Metro East Bicycle User Group Inc.

Response to Options Identification SCC Feasibility Study: Hawthorn to Box Hill

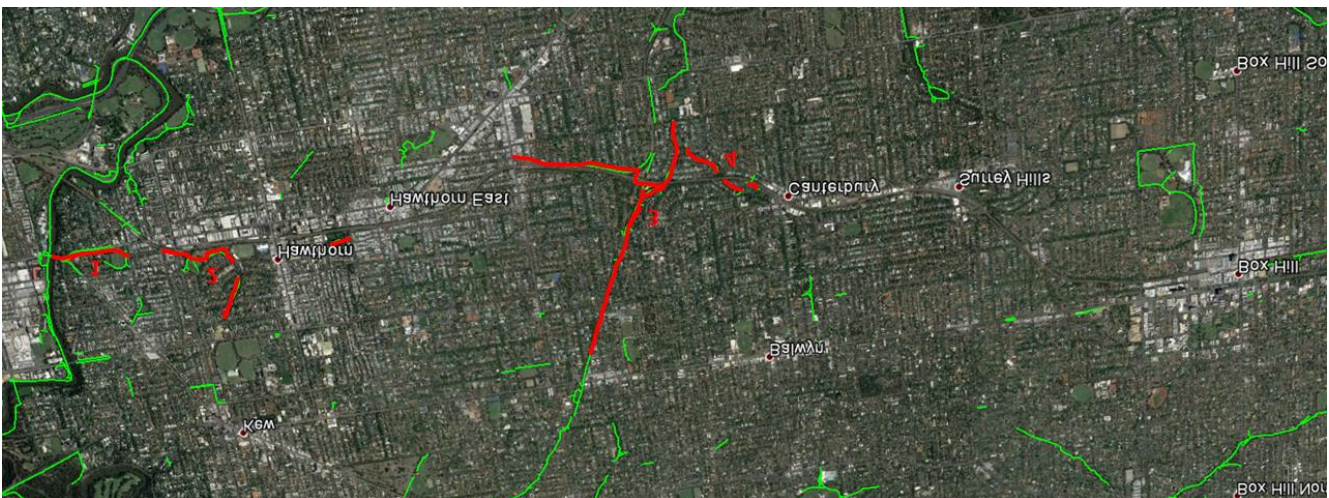
The Metro East Bicycle User Group is generally very impressed with the level of detail with the draft Feasibility Study. However, we have some additional important feedback on matters that weren't fully taken into consideration. These are made on the basis that the initial petition which was a submission for a safe family-friendly bike and pedestrian path connecting Hawthorn to Box Hill. The aim for said trail is to maximise the separated from motor vehicles riding.
